September 7, 2023
File No. 25222081.00

Subject: Materials Management Plan Addendum
Hartmeyer Property Development
2007 Roth Street, Madison, WI
BRRTS #s 03-13-000053 and 02-13-580328

SCS Engineers (SCS) is submitting this Materials Management Plan (MMP) Addendum in response to your email of July 28, 2023, with questions regarding the MMP that SCS submitted on behalf of Lincoln Avenue Capital on July 7, 2023. The questions posed in your email are reproduced below in italics with our responses shown below each question.

FAMILY HOUSING EARTHWORK

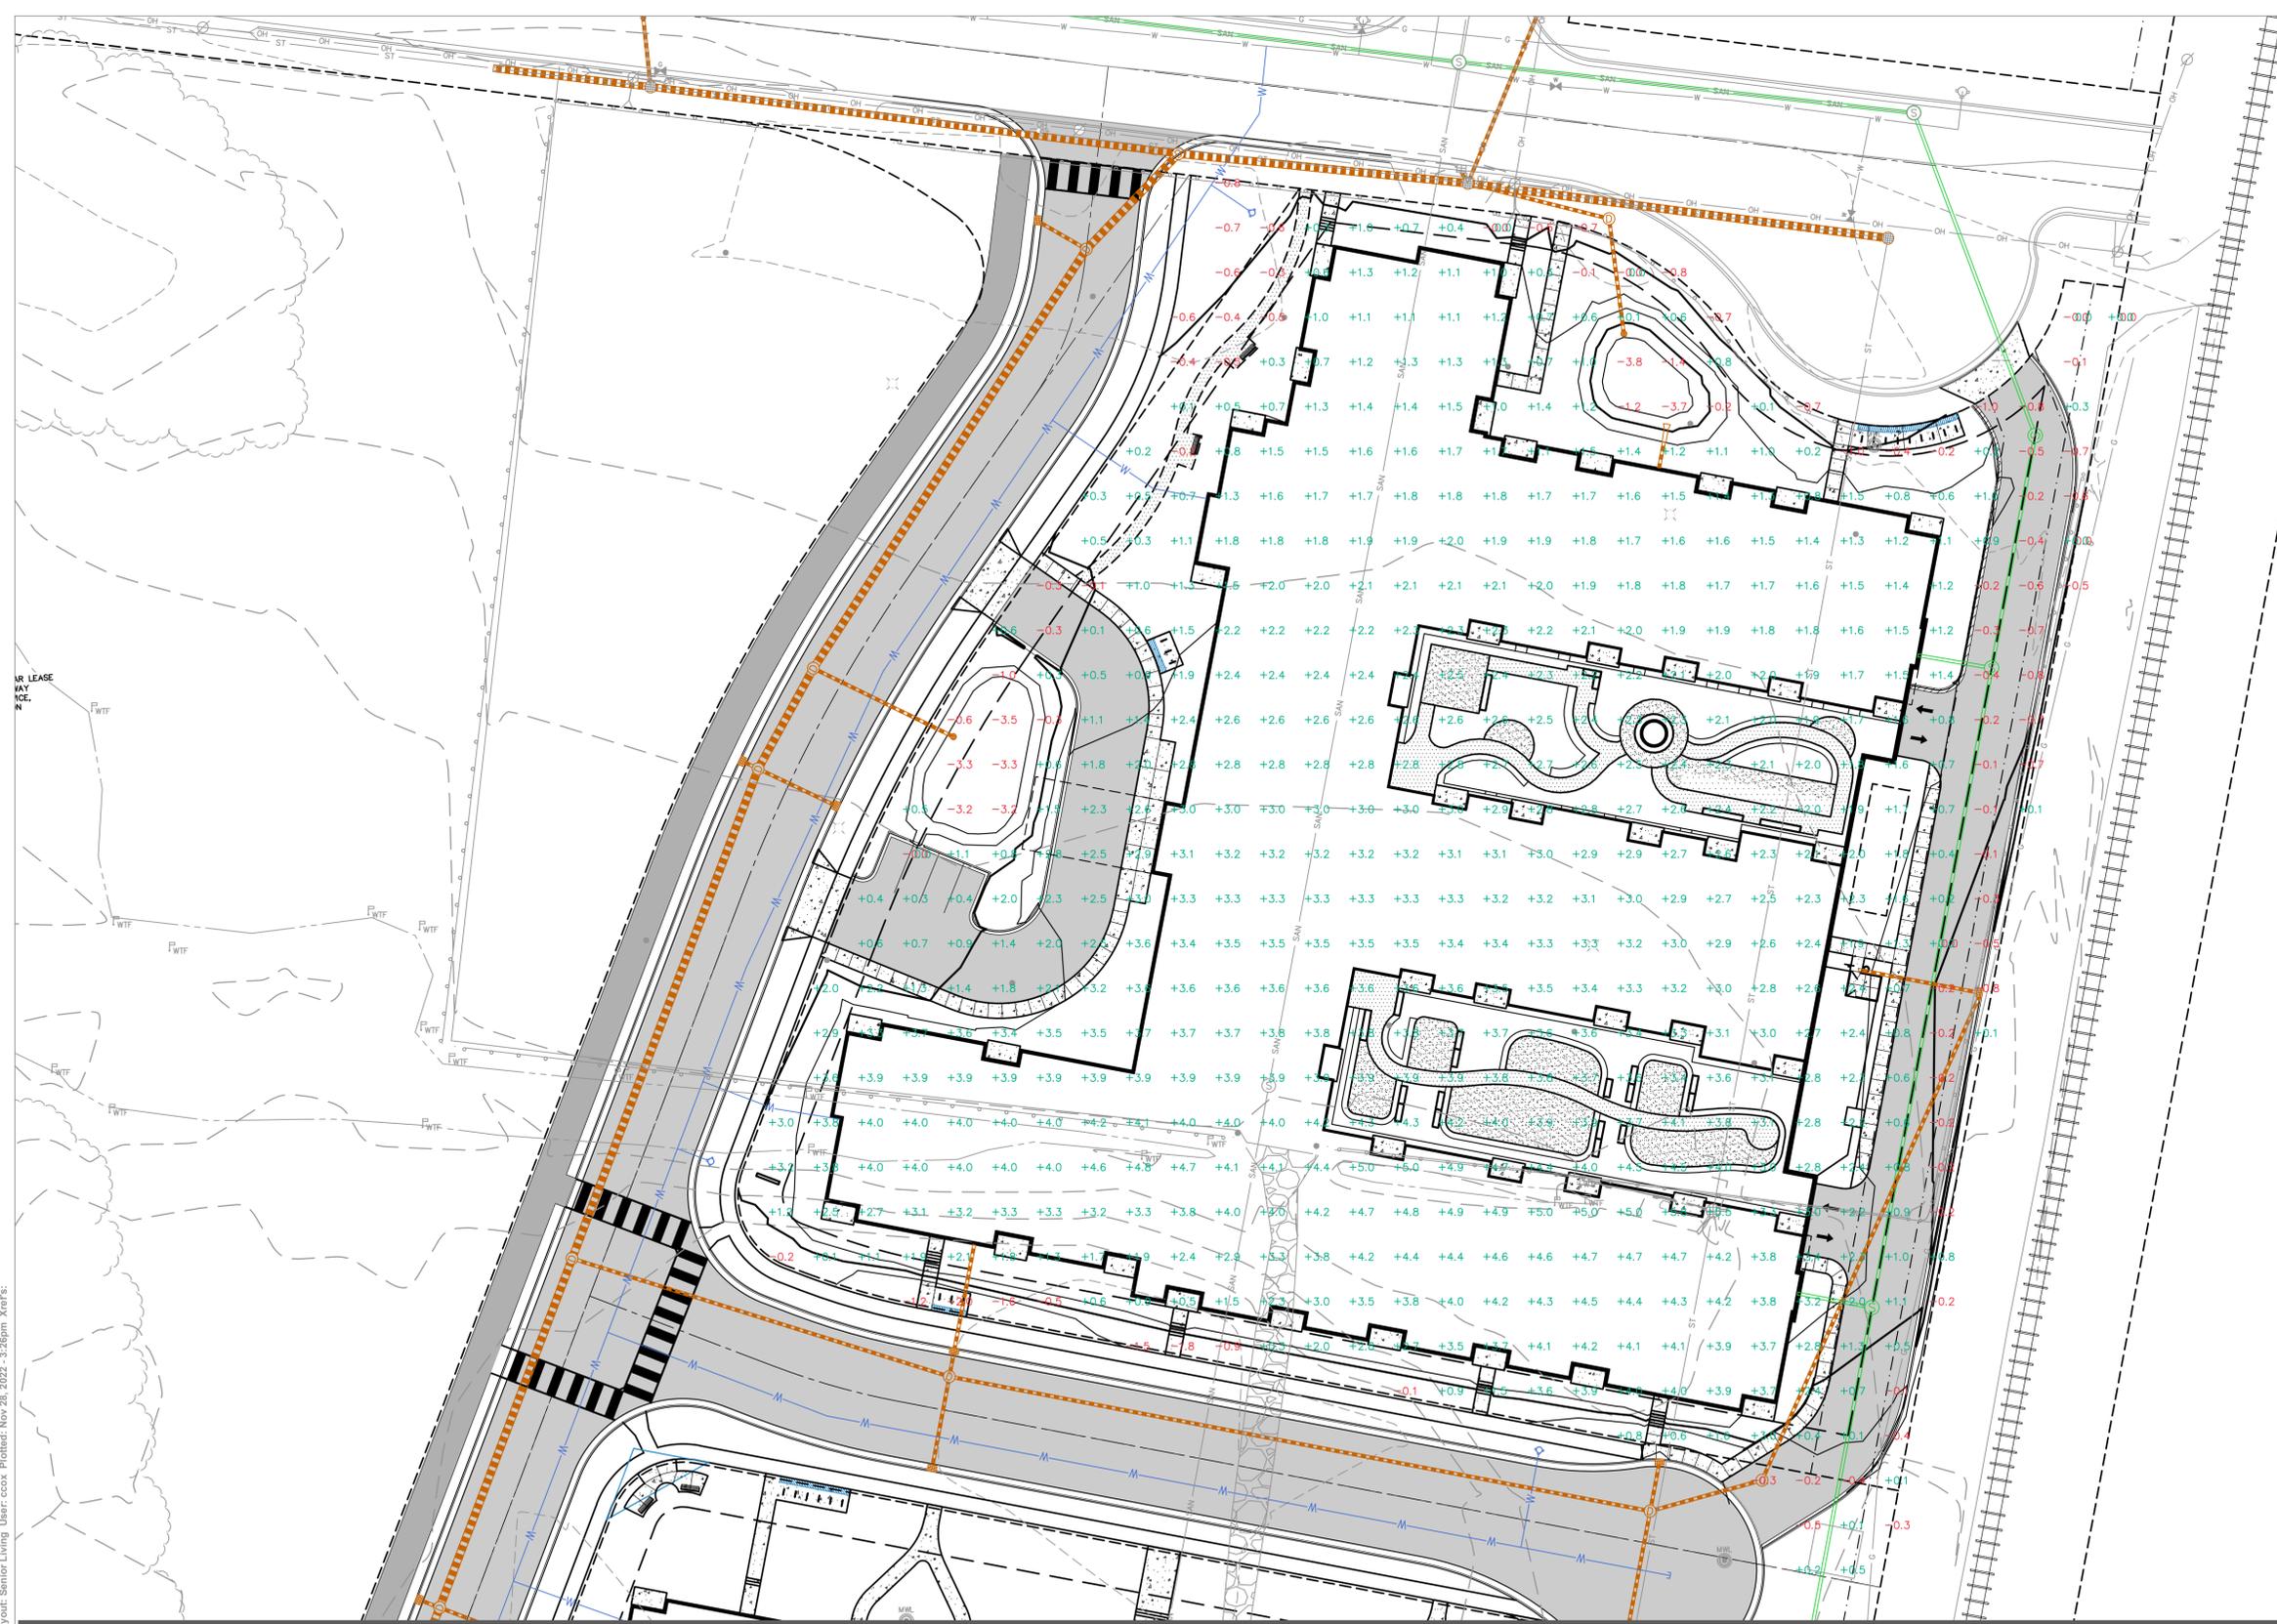
- 2. A cut and fill map or cross-sections showing the depths of excavation (for any purpose: building, road construction, utilities, pool, etc.) and the contaminated soils*

Preliminary drawings showing the estimated cut and fill for site grading and excavation for foundations and on-site utilities are included in **Attachment A**. With the exception of the swimming pool, some storm water features and limited areas around the proposed roads, both the senior and family housing sites show that site grades will be raised as much as 4 feet across the development

area. These drawings show that excavation of contaminated soil will primarily be limited to what is required for the swimming pool, building foundations, utility trenches, and storm water ponds. The proposed swimming pool is located outside the area of identified residual petroleum contamination. With the exception of the northern portion of the south storm water pond, the storm water ponds are also located outside the areas of identified residual petroleum contamination.

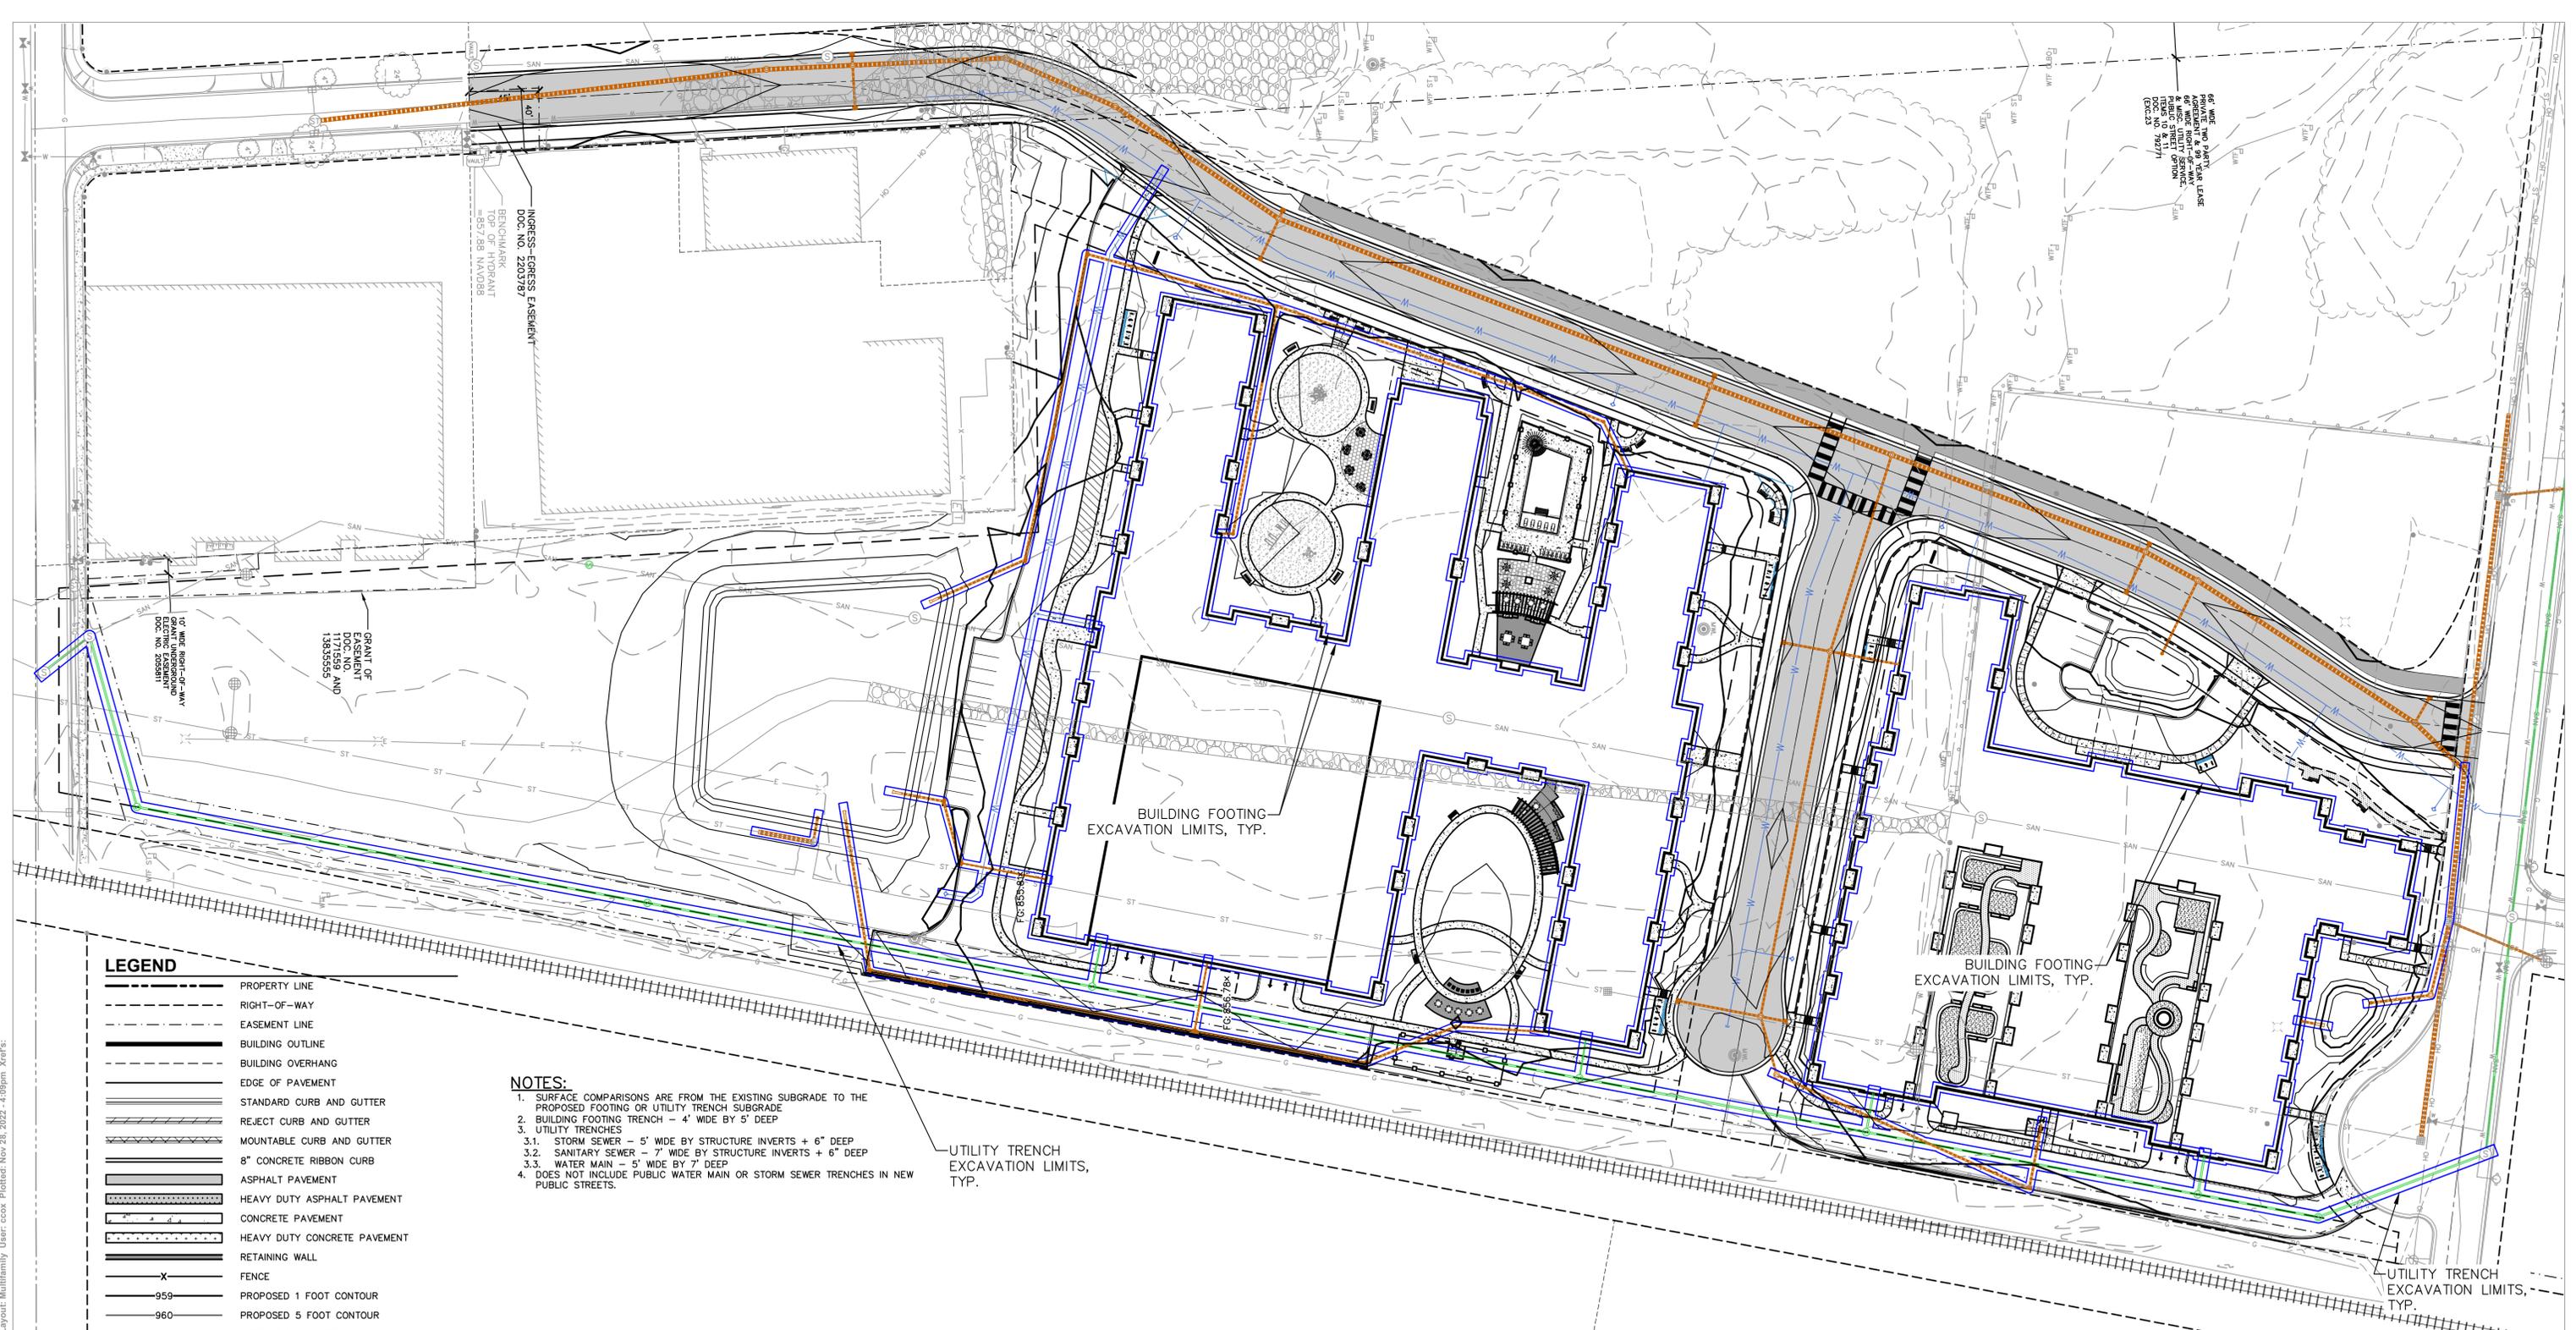
3. *Do the maps already submitted show the proposed utility locations or the current locations?*

Both the previously submitted and updated **Figure 2-Site Plan** show existing underground utilities. Proposed underground utilities (water, storm sewer, and sanitary sewer) are shown on the drawings included in **Attachment A**. Existing utilities that run underneath the proposed buildings will be re-routed.

SHEET TITLE:
**BIOSWALE PROPOSED
TYPICAL SECTIONS**

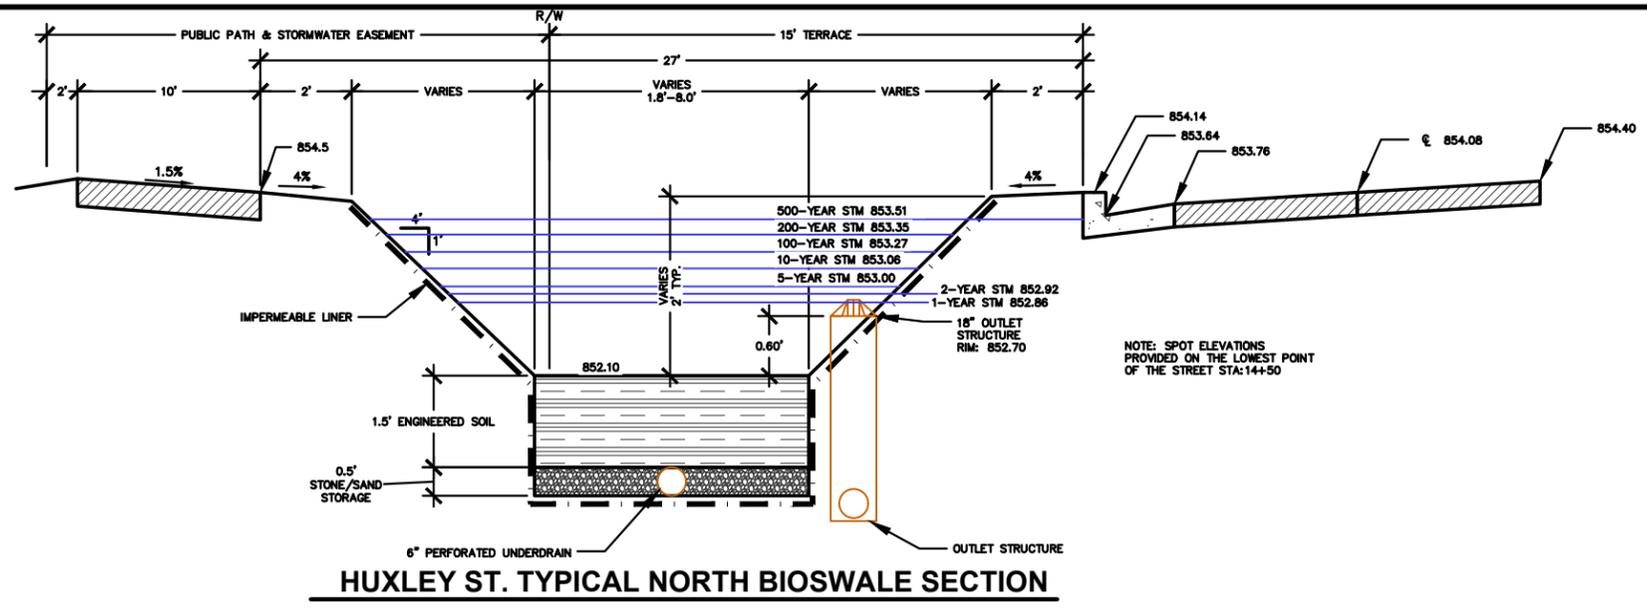
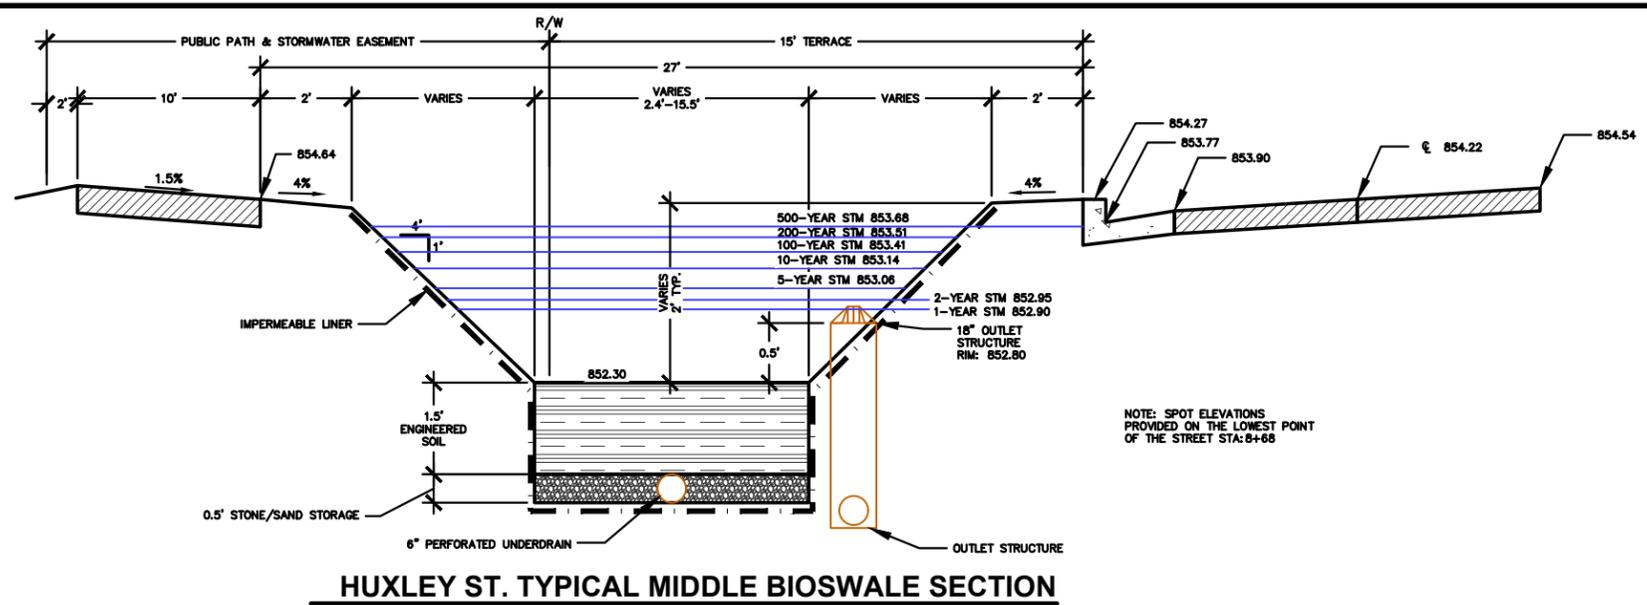
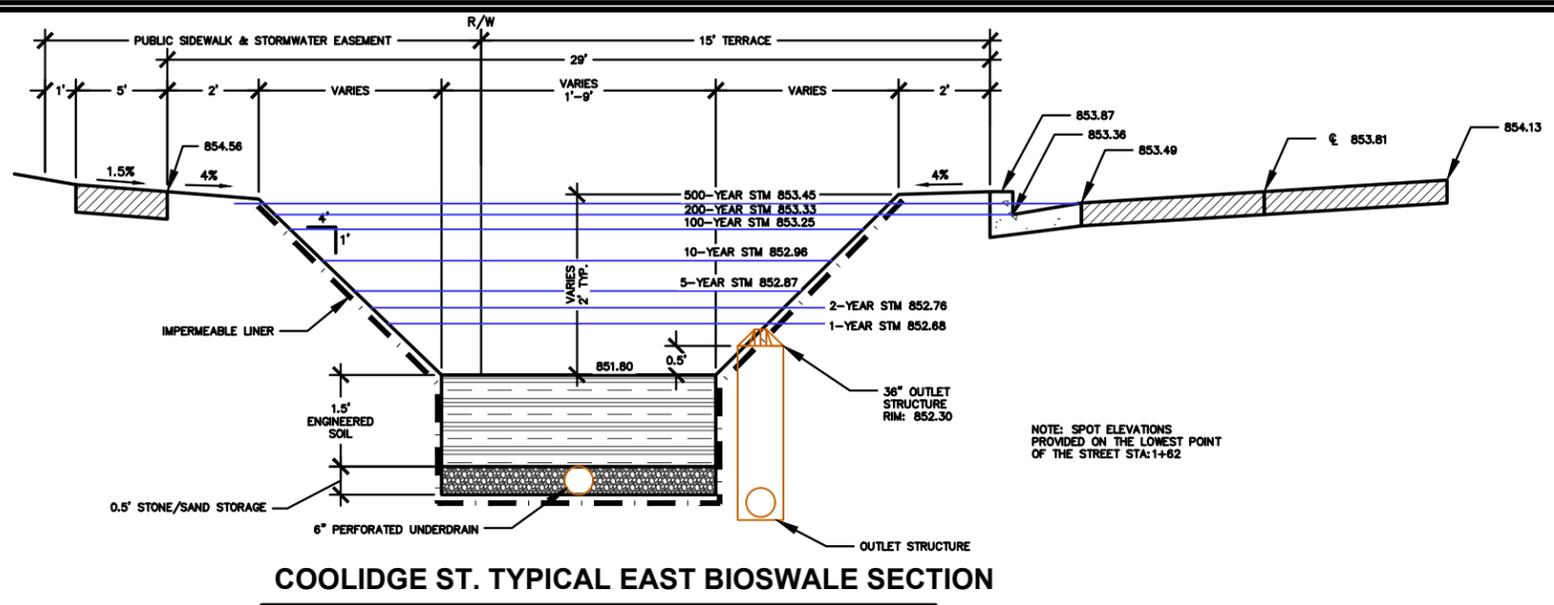
9. *Section 5.4, Protective Cap:*
 - a. *Provide a map indicating proposed capped areas (whether by soil, building, road, or other structure)*
 - b. *DNR's RR-709 guidance (attached, along with its companion document RR-528) recommends 2 feet of clean soil over contaminated soil, instead of the 1 foot proposed in your MMP; discuss whether this can be upgraded to a minimum of 2 feet and how it would be protective if only 1 foot.*
 - c. *Will any of the proposed dog runs or children's play areas, both of which could experience digging, be capped areas?*

The proposed cap is limited to the areas affected by the current redevelopment plans for the property. Because of the relatively widespread nature of urban fill soil and associated arsenic and PAH contamination, the entire developed portion of the property will effectively be capped by new buildings, lined pools or stormwater features, asphalt, concrete, or other paving materials, and/or at least 1 foot of clean soil in landscaped areas. The stormwater ponds will incorporate a 40-mil plastic

liner to prevent infiltration and contact with underlying soil. Bio-swales adjacent to the public streets will also be constructed with impermeable liners. The types of ground cover material are shown on the landscape plans provided in **Attachment B**.
